## **Consolidation of the comments on GRVA-11-03 provided by France and Germany**

## **Artificial Intelligence and Vehicle Regulations**

**Figure 1 – Relationship between AI related standards**

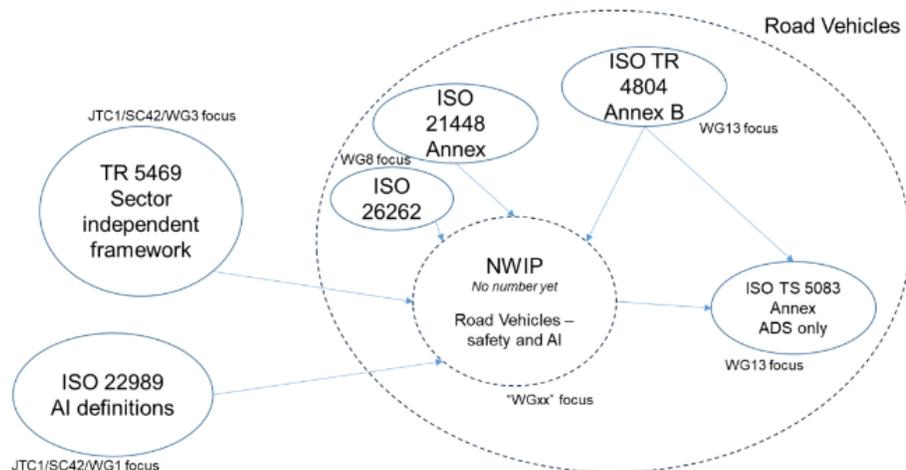
*ISO 22989 represents a very good basis to consider but remains incomplete to date and some definitions (e.g., AI systems) should be reviewed, considering other proposals, such as those issued in the rest of the regulatory and normative environment (e.g., AI Act proposal).*
